City of Santa Fe, New Mexico

memo

2026-012490-HDRB. 507 Paseo de Peralta. Downtown & Eastside Historic District. Marisol Ortiz, agent for Peralta's Walk LLC, owner, proposes to construct a 4,235 sq. ft. multi-family residence to a height of 24'-0" where the maximum allowable height is 25'-0" on a vacant lot.

Figure 3: Proposed Site Plan

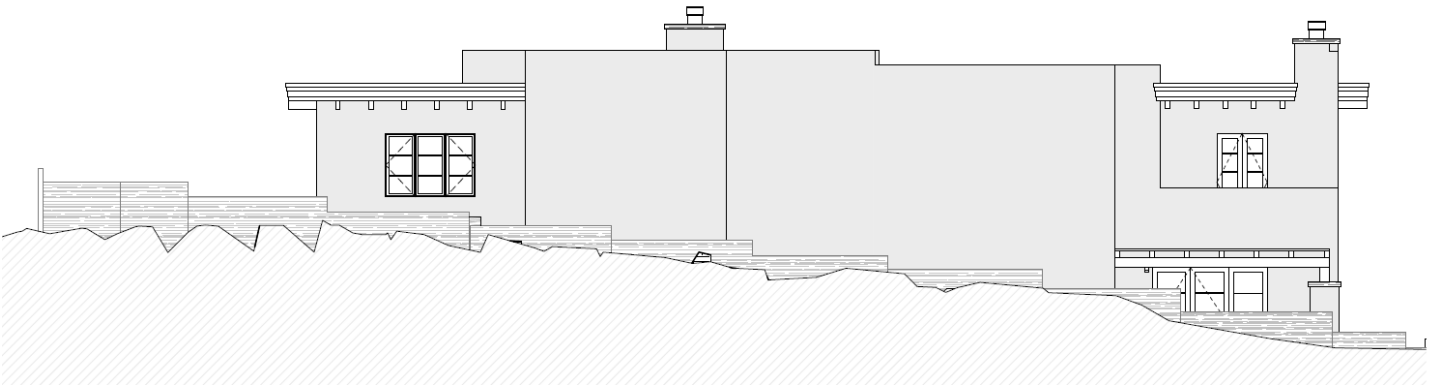
1. Unit 1, change from a single door and double window to a double door and single window under the portal.
2. Unit 2, change from a single door and double window to a double door and single window under the portal.
3. Unit 3, change from a single door and double window to a double door and single window under the portal.
4. Unit 4, change from a single door and double window to a double door and single window under the portal.

1. Unit 3, change the single window and single door to double doors with no windows on the deck.
2. In Unit 3, in Bed 1, install two single windows instead of the double window.
